AMENDMENT OF SOLICITATION/MODIFICATION OF CONTRACT				1. CONTRACT ID CODE J	PAGE OF PAGES 1 70
2. AMENDMENT/MODIFICATION NO. 02	3. EFFECTIVE DATE 26-Nov-2014	4. REQUISITION/PURCHASE REQ. NO. SEE SCHEDULE		5. PROJECT NO.(If applicable)

14. DESCRIPTION OF AMENDMENT/MODIFICATION (Organized by UCF section headings, including solicitation/contract subject matter where feasible.) Modification Control Number: kennedyk15125 Modification to W56HZV-11-D-L-508-0015-02 Reference Request 0010564555-0003 The purpose of mod 02 is to replace failed GFE as follows: 1) CLIN 0013 is hereby incorporated into the contract in support of CLIN 0001 to add funds in the amount of \$6,200.00 for a Soundstructure 8 System with TEL1 Card including a one year warranty at 1.5 Materials List line 72 (page 13) on the task order. 2) The period of performance is extended 6 months for CLINS 0001, 0003, 0004, 0005, 0006 & 0012 as a result of a government delay. Page 4 on the task order changes the completion date from 27 Sep 2014 to 26 Mar 2015 and the POP from 12 months to 18 months. 3) FAR clause 52.217-8, option to extend services, is hereby added to the contract. 4) FAR clauses 43.103(a) Bilateral Agreement and 5

1.4 Conceptual Drawing for Design Objectives

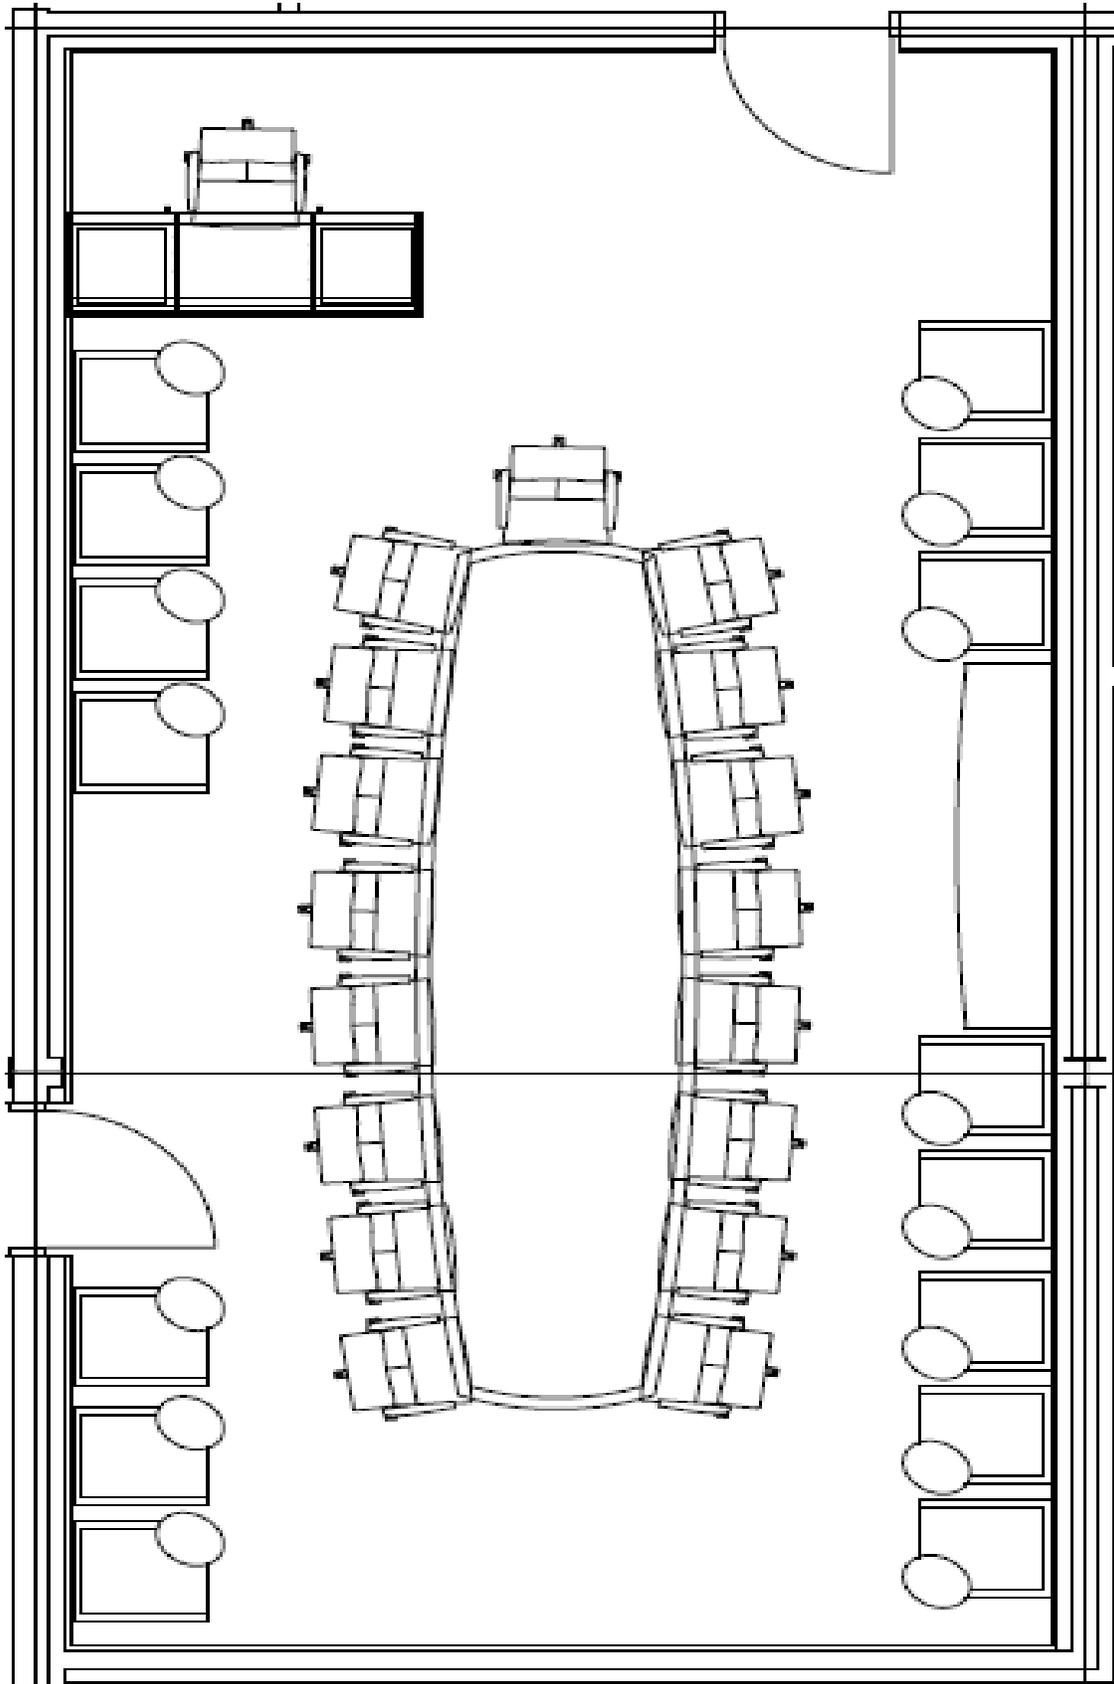
CLIN 0013 is in direct support of CLIN 0001. The materials listed on Line 72 at 1.5 Materials List are incorporated in Task 1 to replace failed GFE.
